State of Alaska
Department of Environmental Conservation
Village Safe Water Program

Re: Amendment 2
ITB 25-VSW-PBV-006
Saint George Water Storage Tank Replacement
ITB Due Date: October 2, 2024 @ 2:00 PM AST

Sheet No. C-1
SHEET 2 OF 4

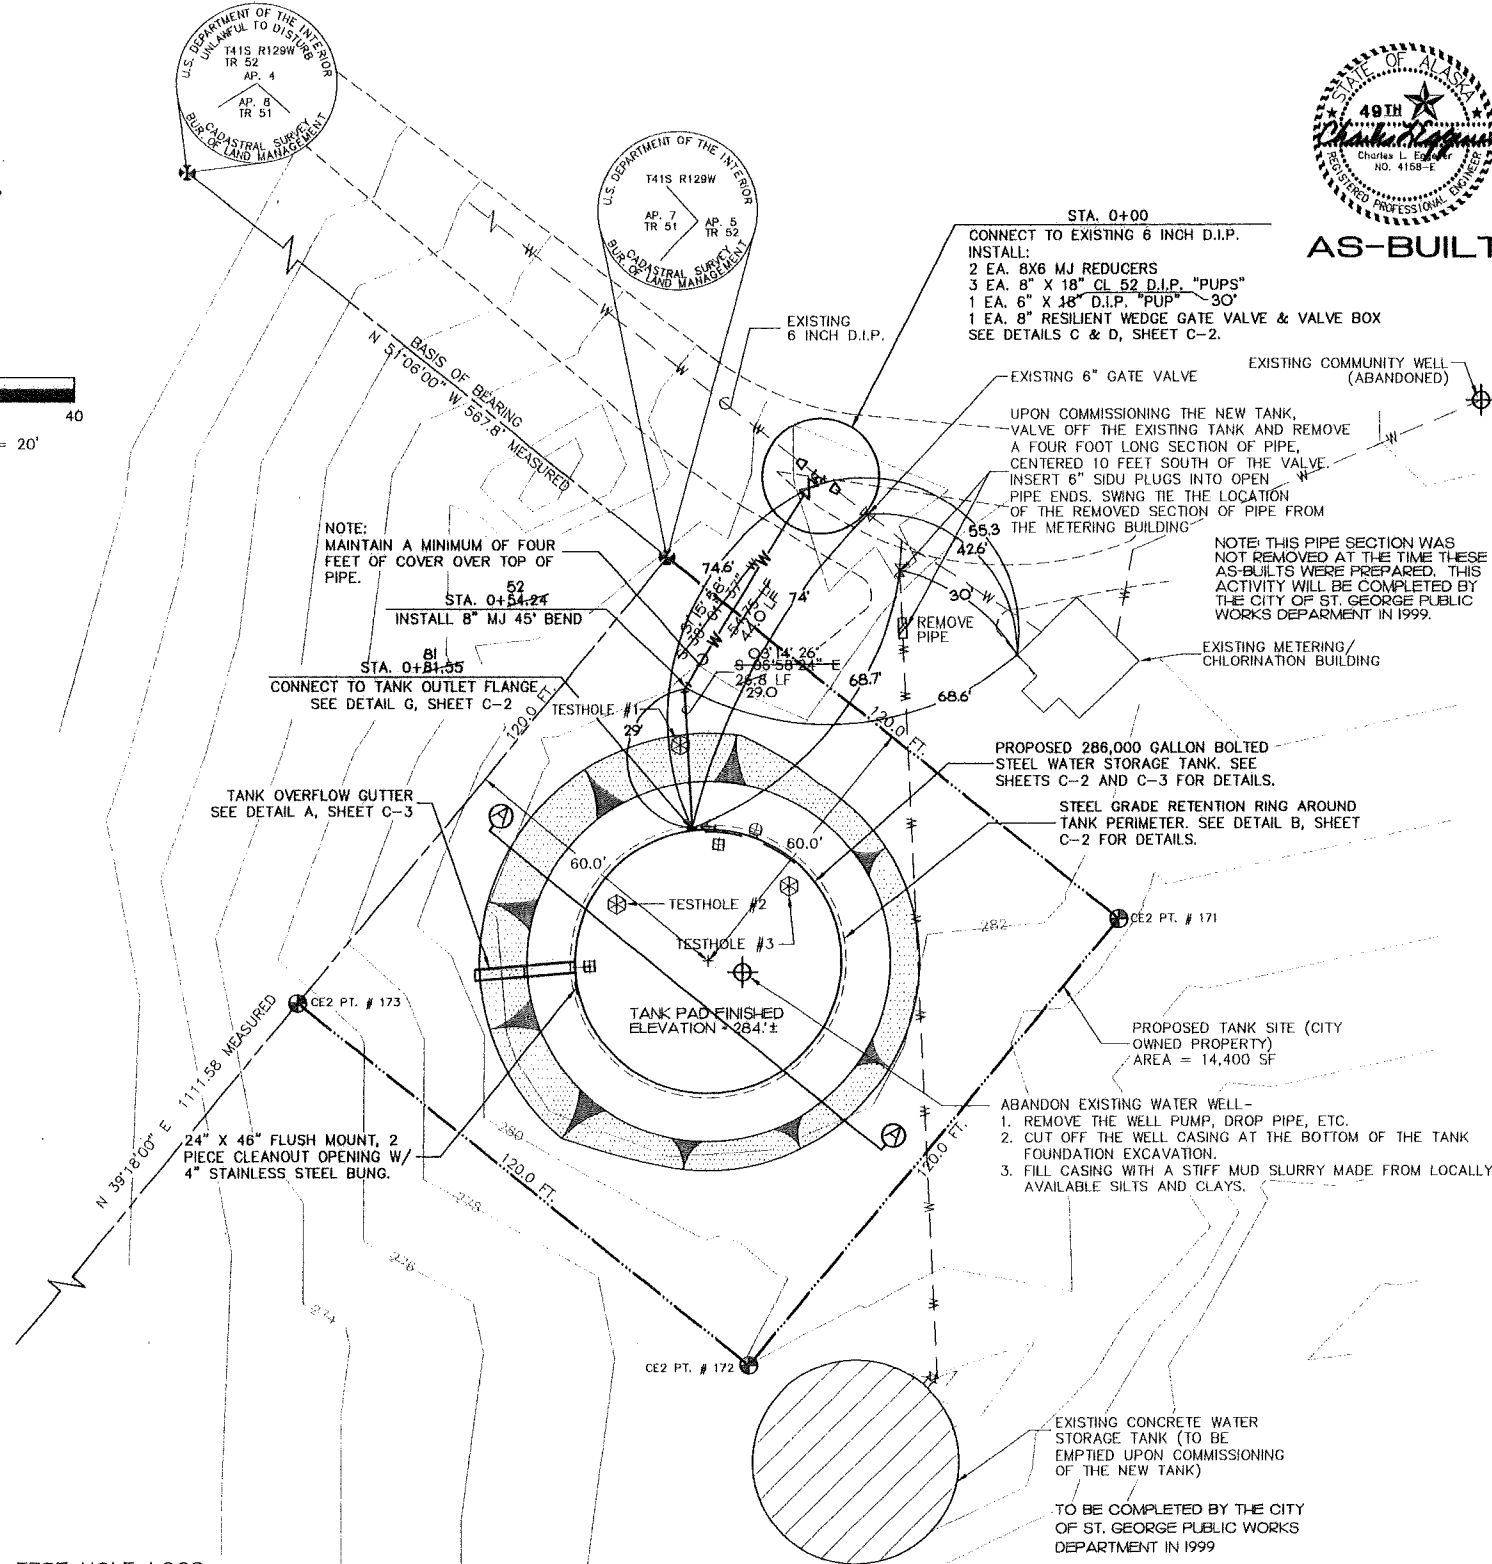
5. Vendor: DWG C1.3 Is there a geotech report or bore hole logs available? Sheet C1.3 identifies weathered bedrock and existing fill of weathered bedrock and gravel from the Gray gravel pit.

Department: The attached record drawings of the existing tank include test hole logs (on Sheet C-1) for three test holes excavated prior to construction, and document construction of the existing tank pad. The attached report dated 3/17/2023 by WSP documents their reconnaissance and preliminary recommendations regarding the existing tank pad and construction of a new tank on the pad.
